**Bid No. 16-10 – Primary Data Center Installation
Philadelphia International Airport
Addendum Two**

PPA PUBLIC BID NO. 16-10
INTERIOR AND EXTERIOR ALTERATIONS
TO THE
PHILADELPHIA PARKING AUTHORITY
ADMINISTRATION BUILDING
FOR A
NEW PRIMARY DATA CENTER INSTALLATION

MECHANICAL DEMOLITION & NEW PLAN

2 MECHANICAL NEW PLAN
M1 SCALE: 1/4" = 1'-0"

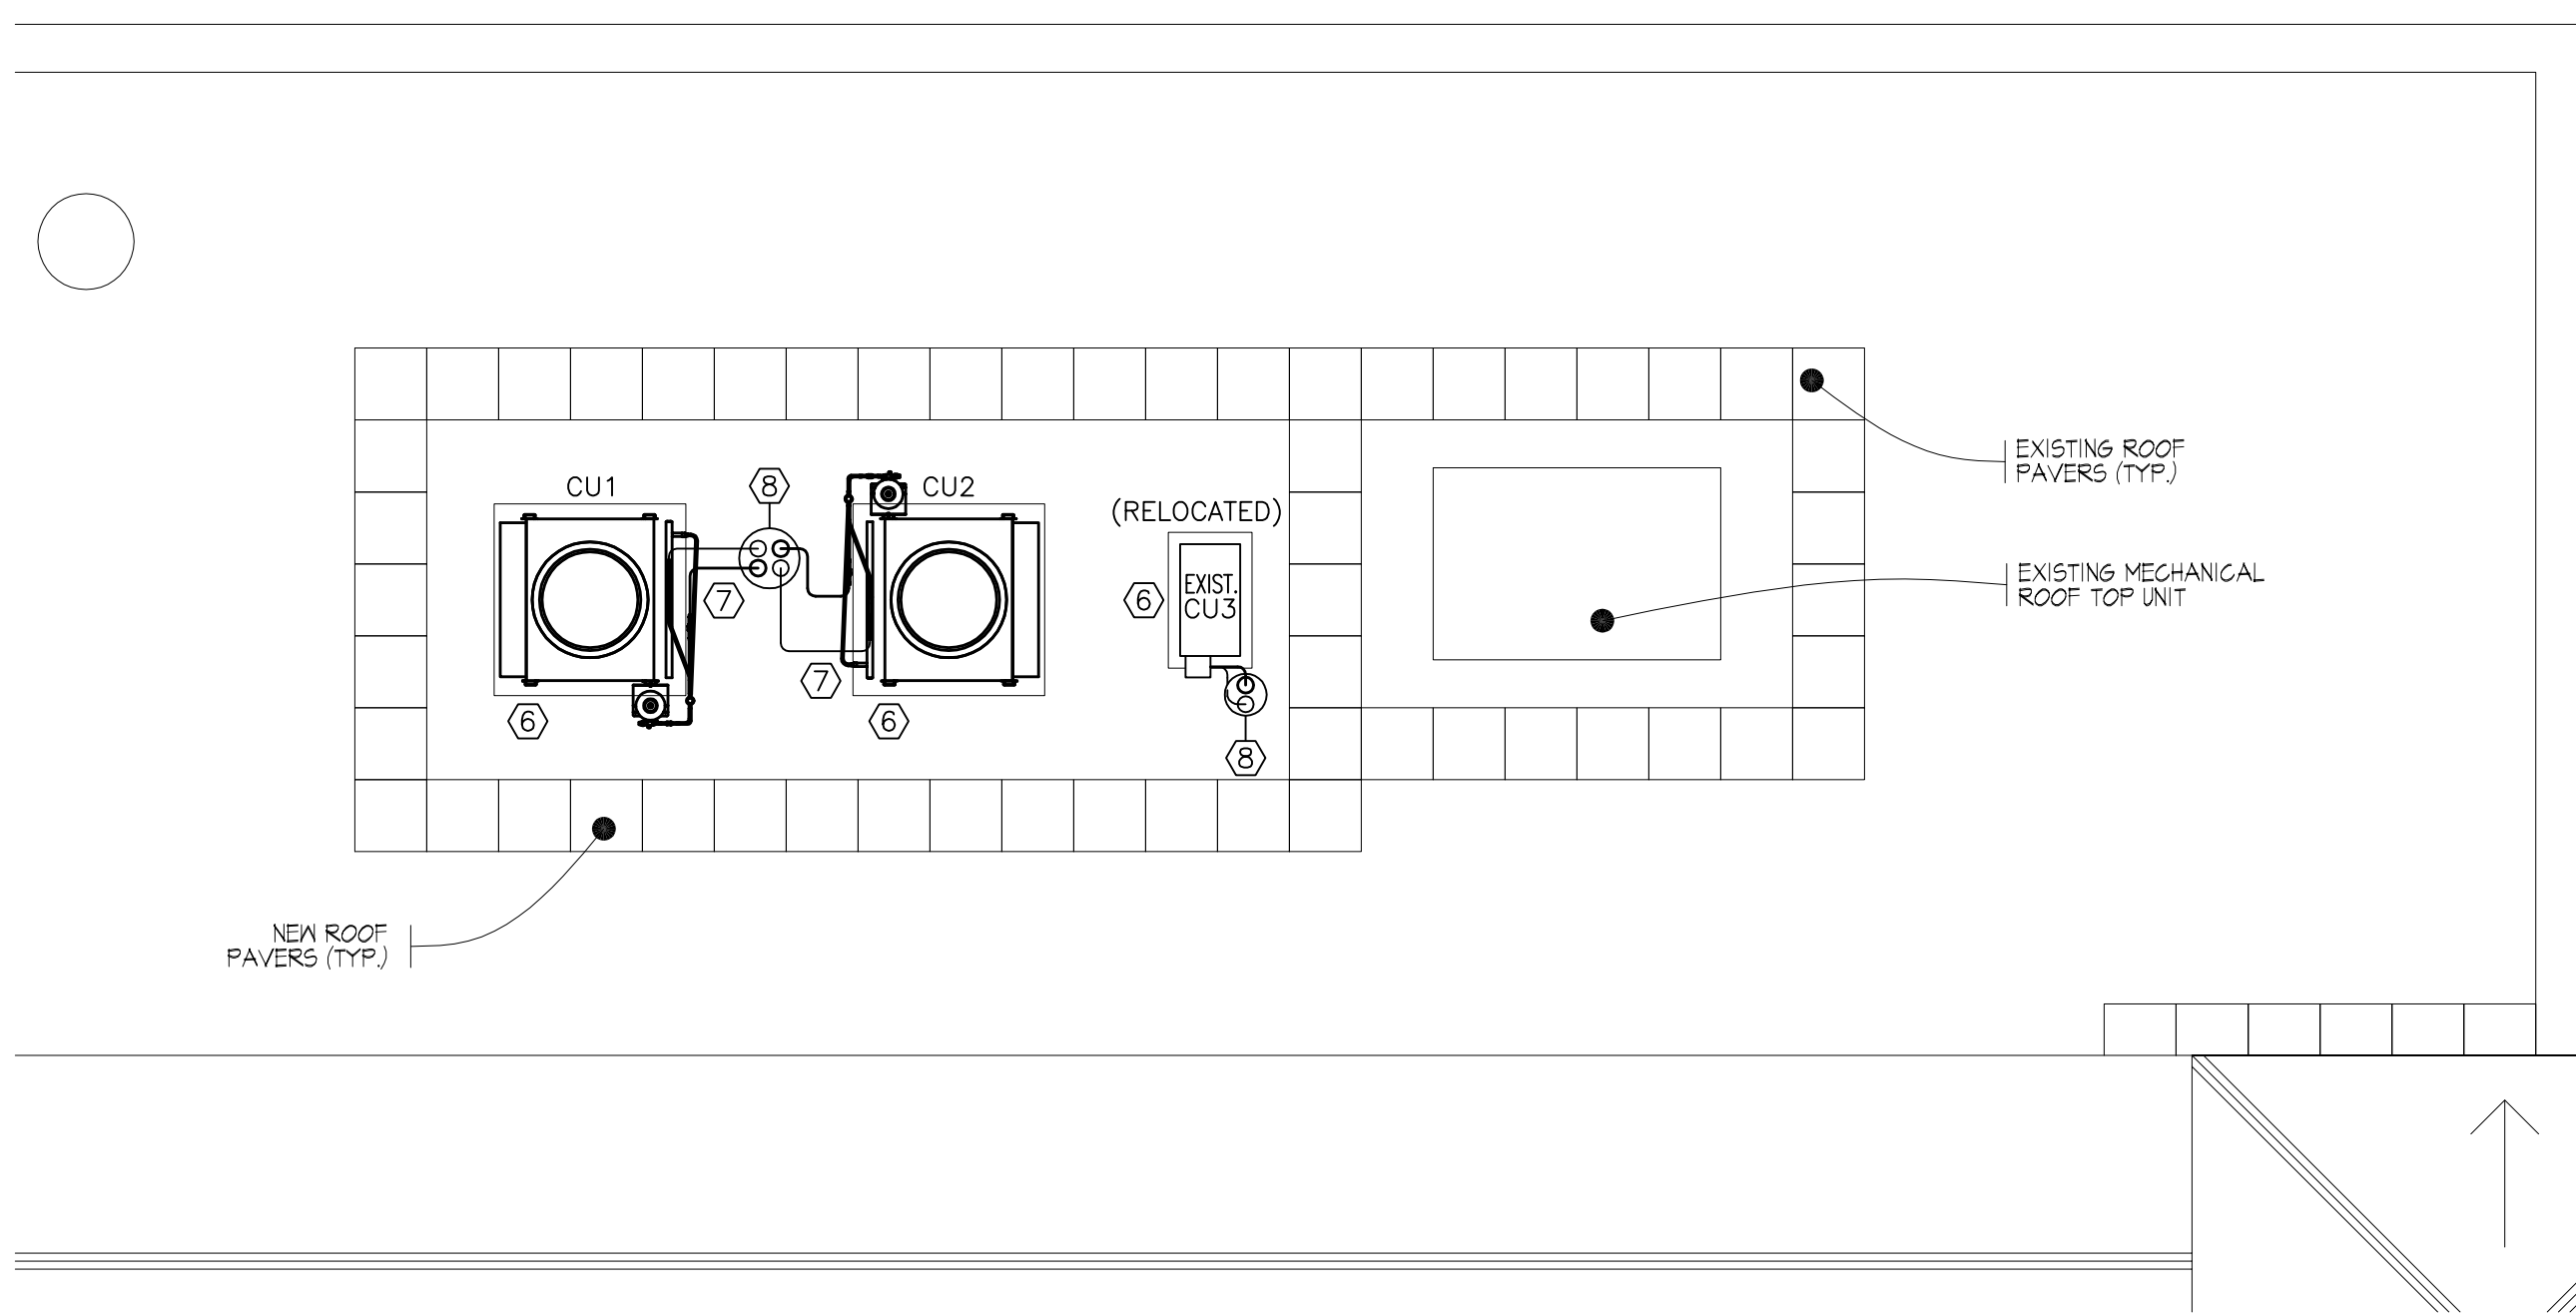
1. Drawing M1: The drawing was revised to show the rerouting of the condensate line to a new tie-in location at an existing 4" interior storm drain line. Detail 5/M1 was also added to detail the connection method at this tie-in point. Refer to Detail 5/M1 and Keyed Note #3.
